RESPONSE TO COMMENTS

IDCP RESPONSE TO COMMENTS

CHAPTER 3 OPEN SPACE

FIGURE R3.1.1

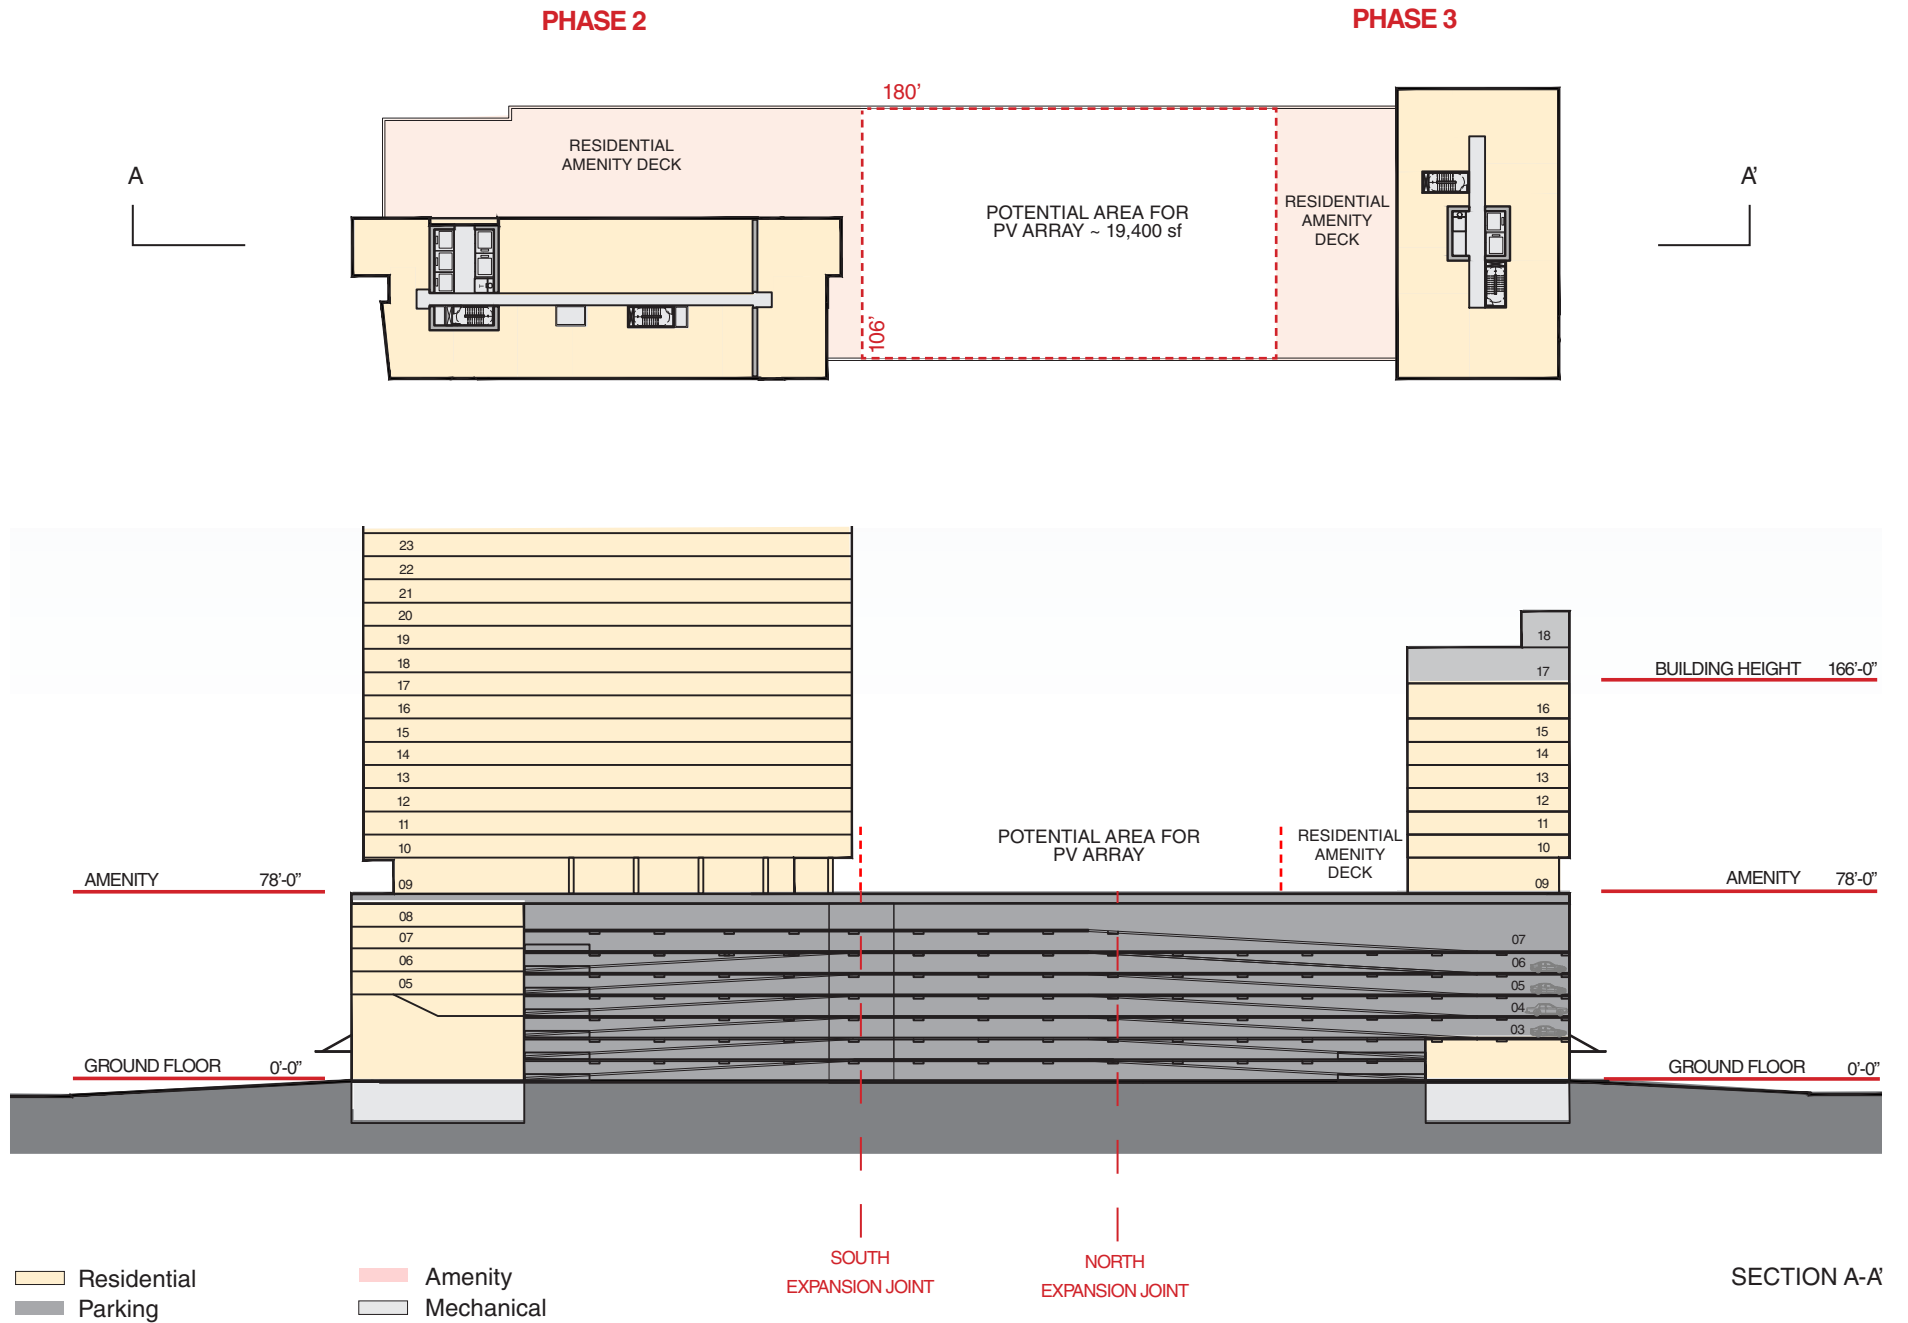
Applicant received several comments and questions about whether the Blue Garage will include open space for residents and what other uses may be considered in areas that are not private. As shown in **FIG. R3.1.1**, the Blue Garage will include two, separate private open spaces immediately abutting each residential project on the north and south sides of the garage. The area in between both open spaces is proposed as a solar array that will provide energy generation specifically for the residential projects.

FIGURE R3.2.1

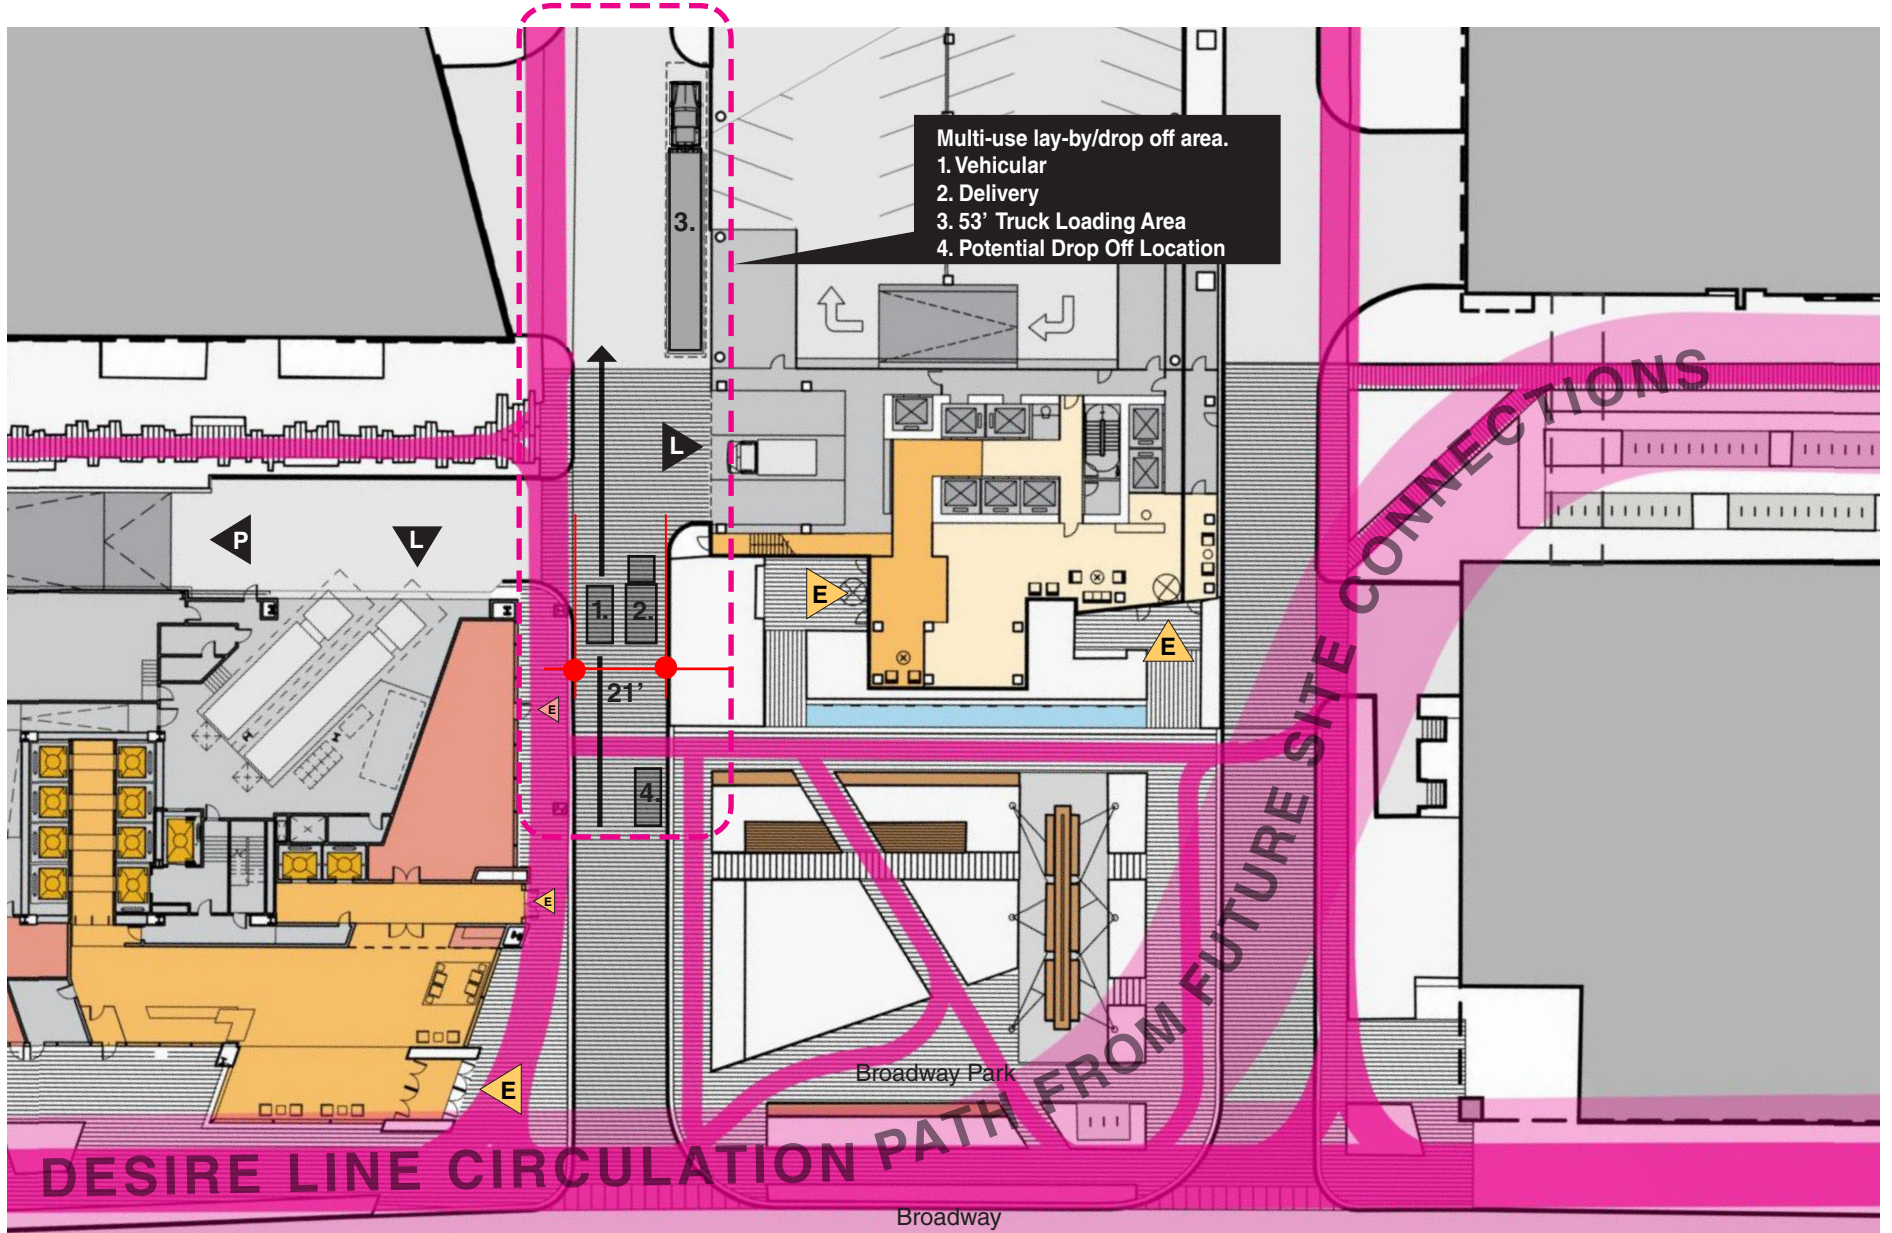
R3.2.1 DIAGONAL PATHWAYS: Applicant received different comments about the diagonal pathways and desire lines through the park. Applicant notes the comments and is willing to study desire lines further but recommends that this level of review occur at the time of design review for Phase II consistent with the MXD IDCP Chapter 9 Phasing Plan.

FIGURE R5.2.1

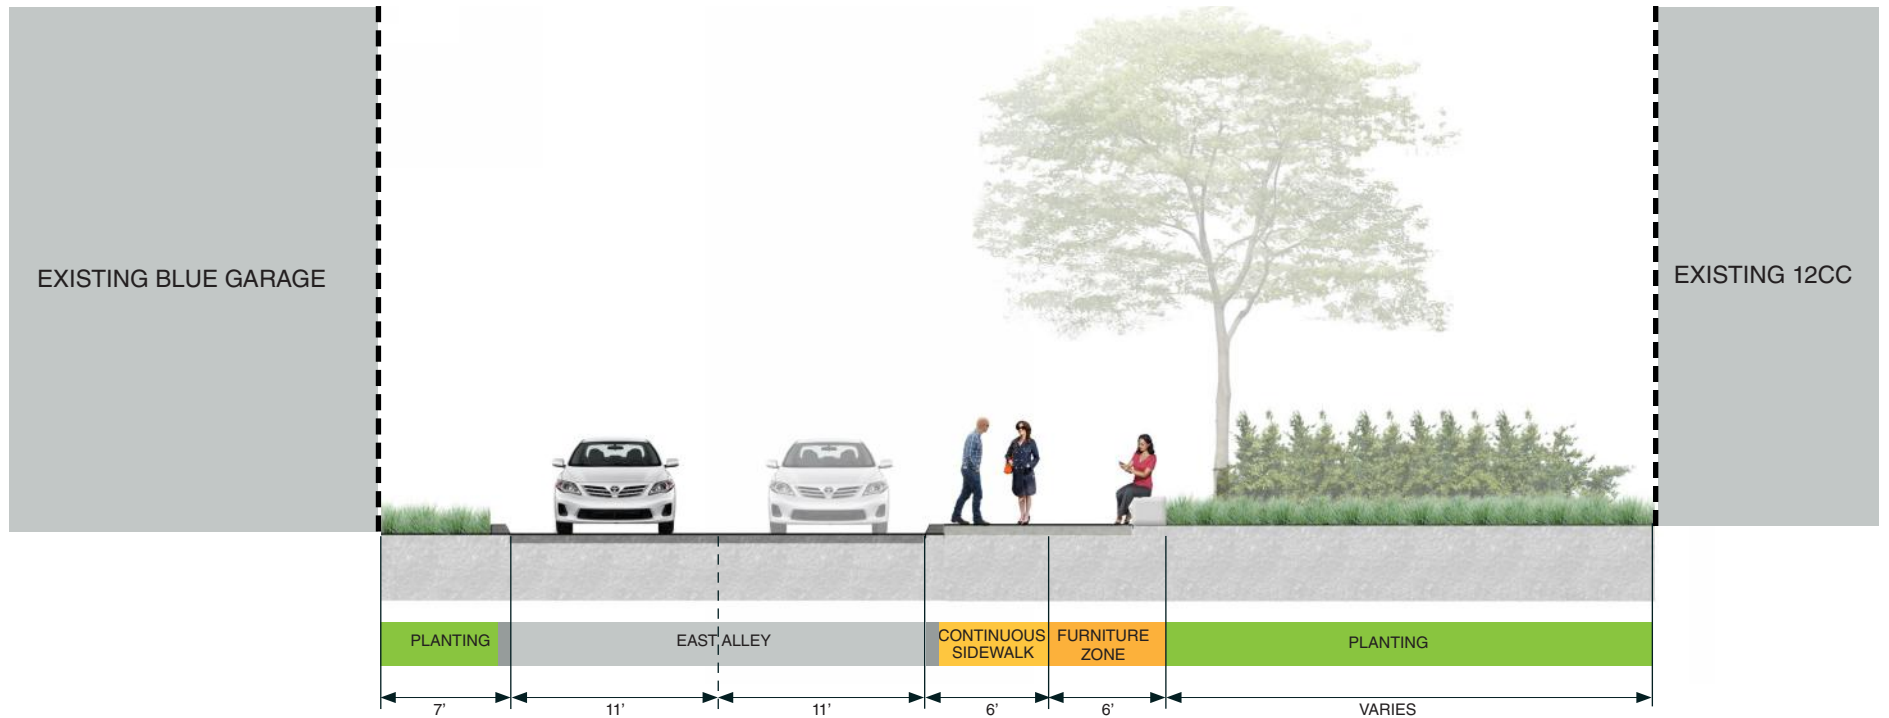
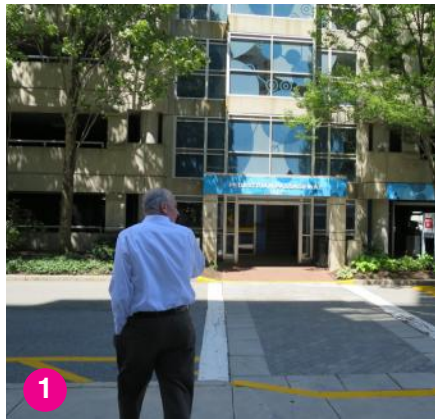
Applicant received questions on whether the Blue Garage as well as the garage at 145 Broadway and 250 Binney Street are planned to be publicly accessible **FIG. R5.2.1** and where visitor parking will be accommodated. The Blue Garage is publicly accessible and currently has 500 spaces allocated for commercial use. 145 Broadway and 250 Binney Street are not planned for public use but will be designed to accommodate visitor parking. The parking for the residential buildings is planned in the Blue Garage. Additional specific information on parking will be provided in the PTDM plan to be submitted by Applicant.

FIGURE R5.1

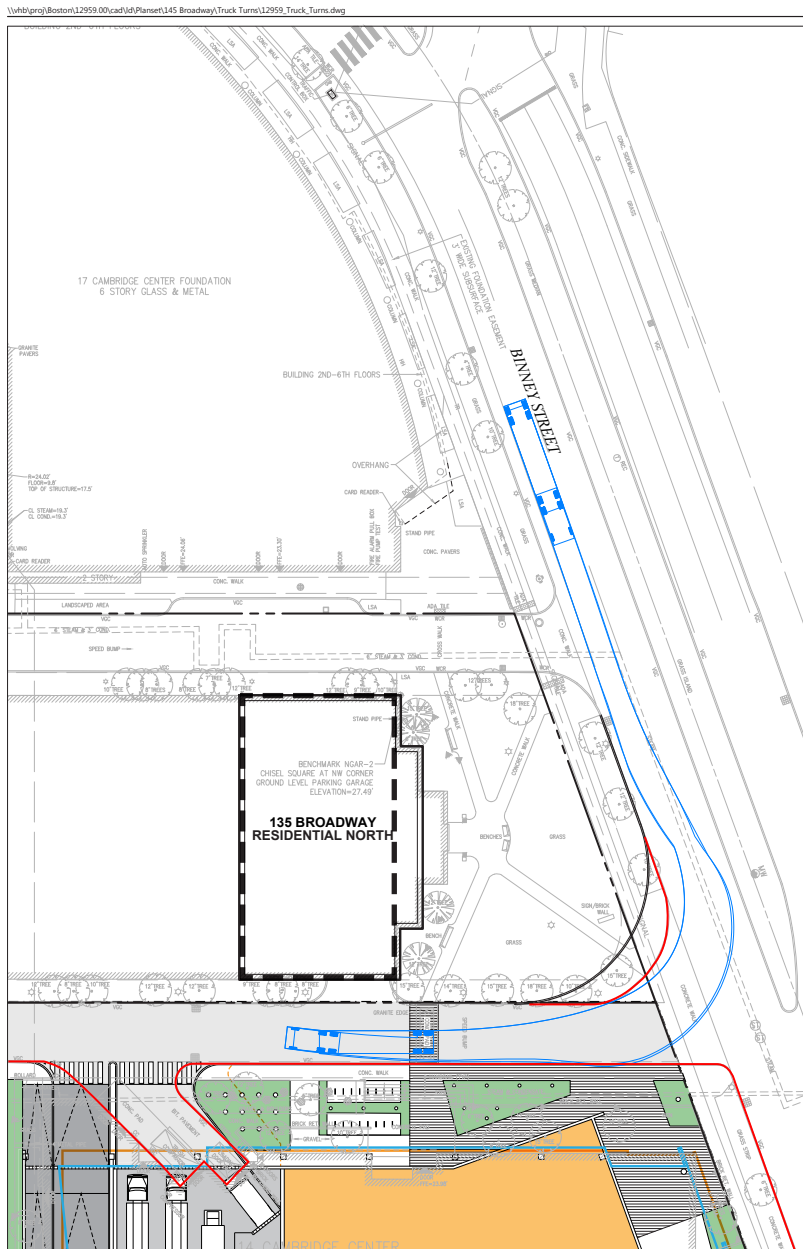
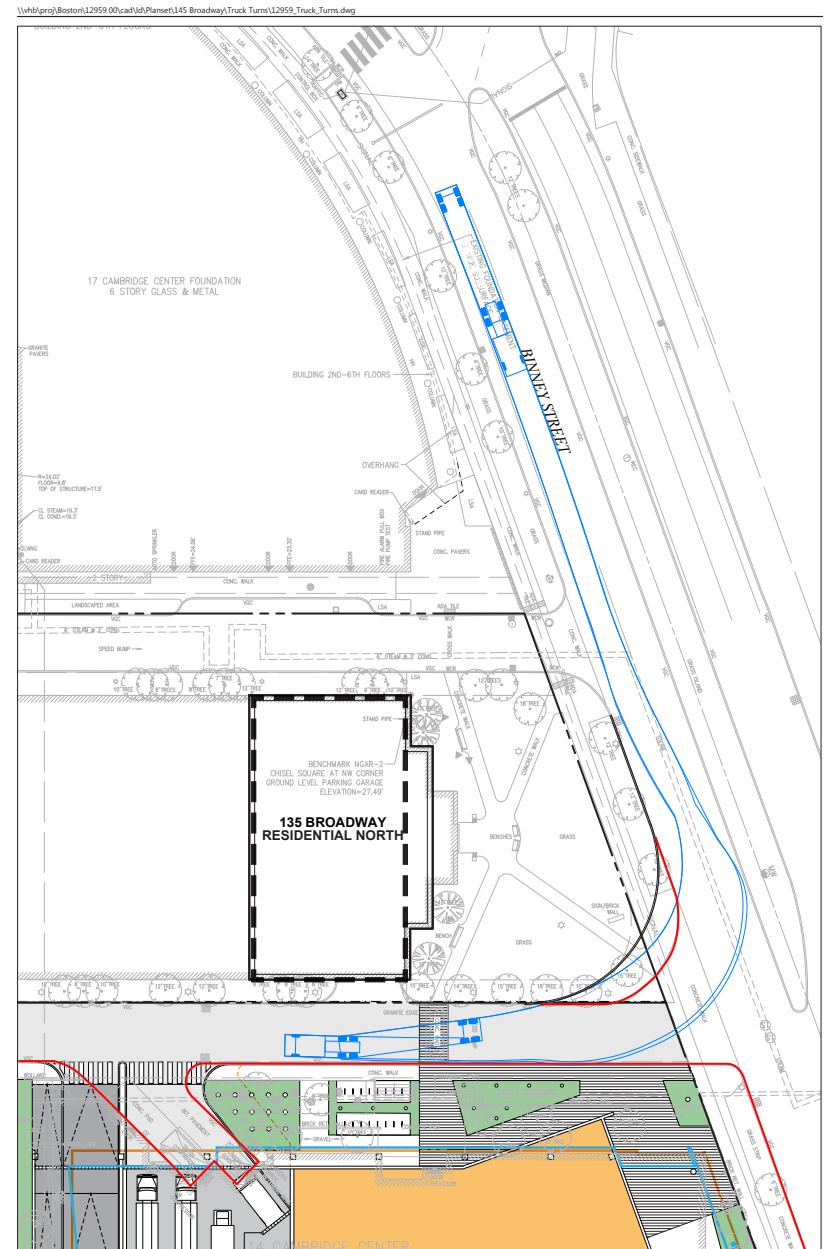
Applicant received the comment that the turning radius from Binney into the site was too large. The radius of that connection is designed to accommodate deliveries from trucks with 53' trailers as shown in **FIG. R5.5.1**

FIGURE R7.1.2

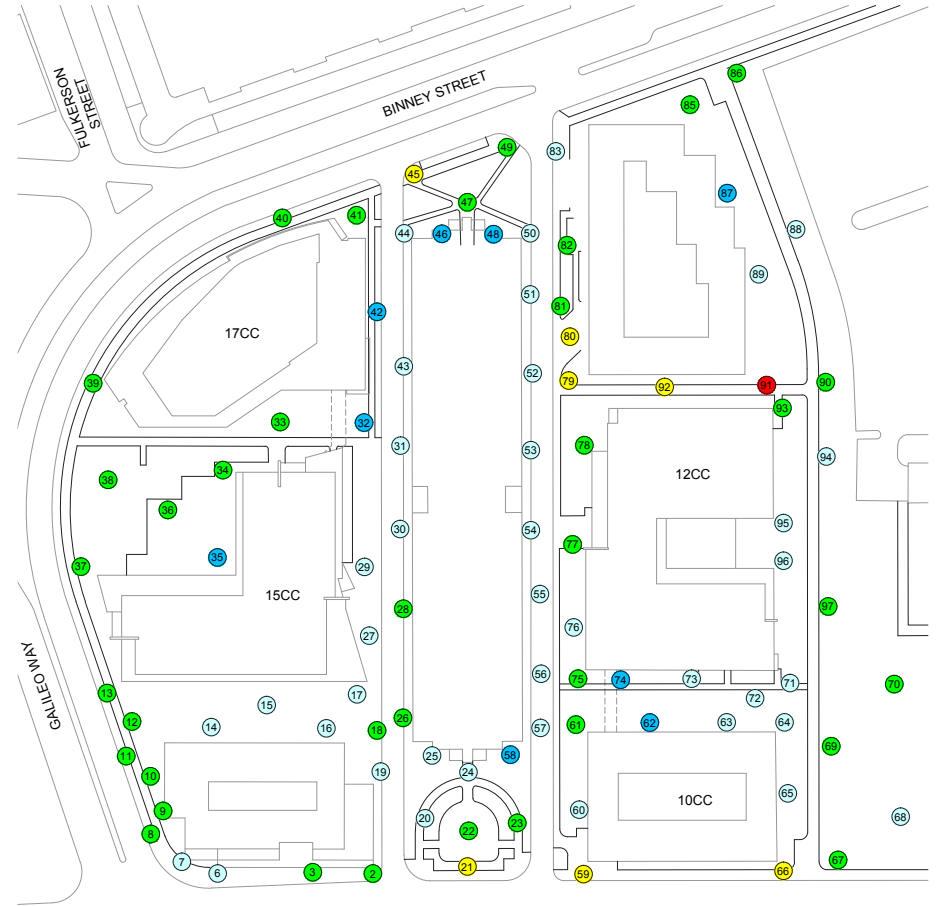
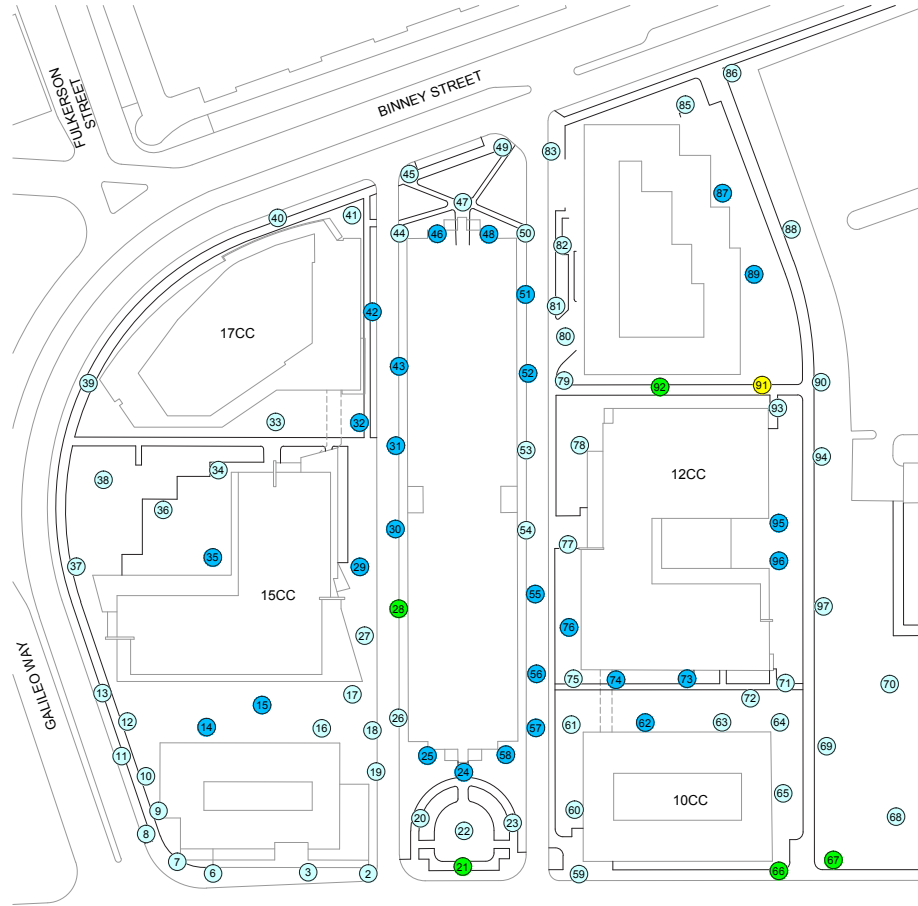
Applicant received general questions about wind and comments about the sufficiency of the desktop wind study provided in the MXD IDCP submission from August 9, 2016. Chapter 7 of the MXD IDCP included a selection of the desktop wind model run by RWDI on the initial massing of all four proposed buildings. In addition to these select elements of the analysis, the entire desktop study can be found in the appendices located on the CD rom attached in the back sleeve of the MXD IDCP book and submitted electronically to the Community Development Department. Applicant understands the concern about wind, however, wind tunnel analysis is sensitive to changes in massing. Accordingly, Applicant proposes that each building provide a wind tunnel analysis during Design Review after massing has been approved as part of the Infill Development Concept Plan and at a time when the building design can be appropriately altered to respond to a wind tunnel study. For the purposes of comparison, Applicant has included a wind tunnel analysis of existing summer and winter conditions **FIG. R7.1.2** serve as a baseline for future review.

FIGURE R9.1.3

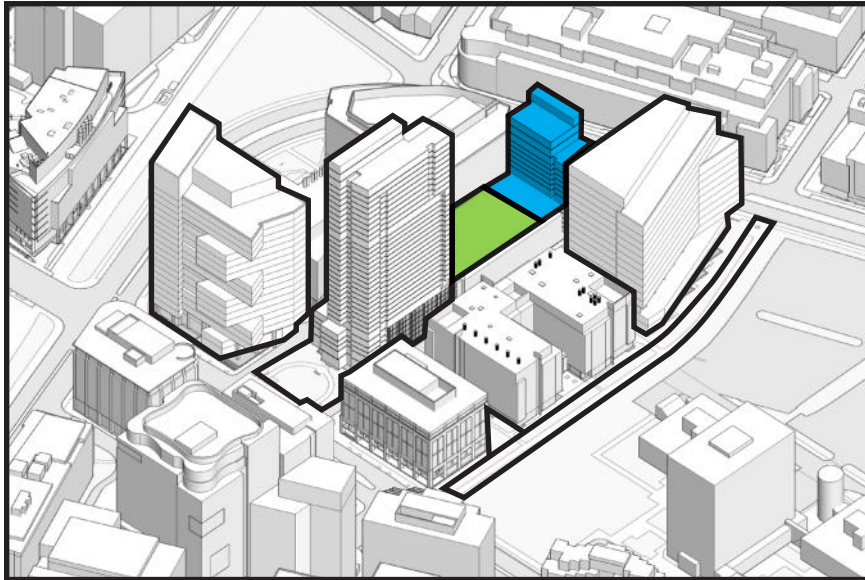
Applicant received multiple requests for clarification on the phasing of each open space related to the project including the parks and east to west pedestrian connector paths. A color-coded plan showing greater detail of the open spaces that will accompany each building and phase is represented in **FIG. R9.1.1** for Phase I, **FIG. R9.1.2** for Phase II and **FIG. R9.1.3** for Phase III. Also, describing the Open space related to project phasing is **IDCP revisions 3.2 Proposed Open Space**. Each phase indicates the required open space per allotted GFA for that phase and demonstrates that through provided open space and enhanced existing open space that each phase provides more than the necessary open space area.
